CP-200800213
Log # TXX-08025

SUBJECT: COMANCHE PEAK STEAM ELECTRIC STATION
DOCKET NOS. 50-445 AND 50-446
SUPPLEMENT TO LICENSE AMENDMENT REQUEST (LAR) 07-004
REVISION TO THE OPERATING LICENSE AND TECHNICAL SPECIFICATION 1.0,
"USE AND APPLICATION" TO REVISE RATED THERMAL POWER FROM 3458 MWT
TO 3612 MWT. (TAC NOS. MD6615 AND MD6616)

**RESPONSE TO REQUEST FOR ADDITIONAL INFORMATION
MECHANICAL AND CIVIL ENGINEERING BRANCH (EMCB)**

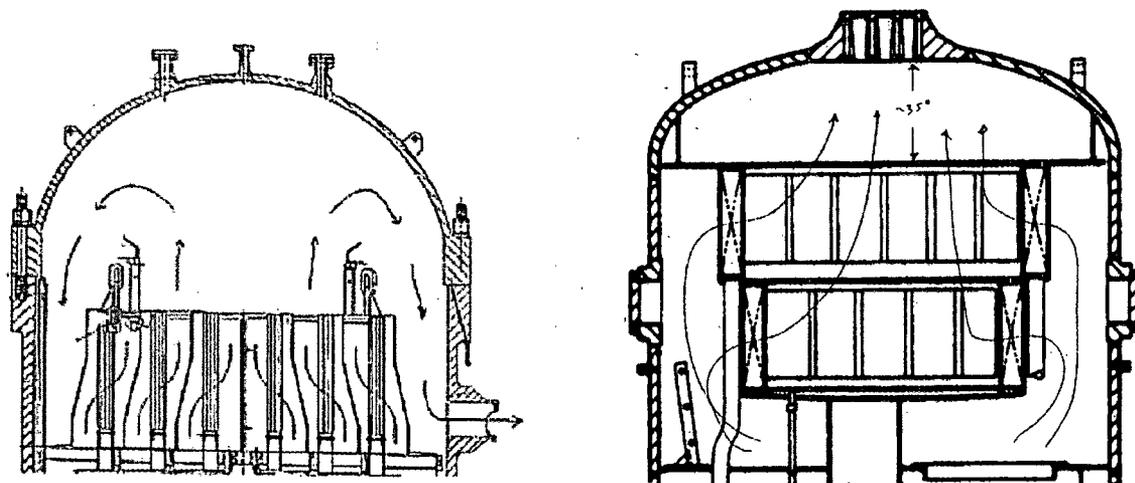
- a) Provide similar summaries for CPSES, Unit 2.
- b) Include FIV analyses summaries for the steam dryer, dryer supports and flow-reflector with respect to the fluid-elastic instability, acoustic loads and vortex shedding due to the SPU higher steam flow for both CPSES units. If FIV analysis for the dryer, supports and flow reflector has not been performed or FIV is not thought to be a concern for these components, provide an acceptable justification.

Flow loadings, including those associated with fluid-elastic instability, vortex shedding or acoustic type loadings are considered to be not significant in the analysis of the steam generator (SG) dryer and dryer supports and other steam generator internals. There are no existing conditions in the piping systems connected to RCS loop and components e.g. Main Steam Lines, as potential source for flow induced acoustic resonances or system vibration to adversely impact any of the RCS components such as steam generator internals. For example, there are no long cantilever branch lines or branch lines with heavy unsupported valves. Further there is no history of vibration problems in these lines at CPNPP, nor at other 4 loop Westinghouse-designed reactors. In-service experience has revealed no such phenomenon related to PWR and with the SPU increased flow conditions these effects will be monitored through existing plant loose monitoring procedures, in-service inspections and system walkdowns for plant vibration assessment as reasonably achievable following SPU, as provided in Response to RAI # 16 & 17.
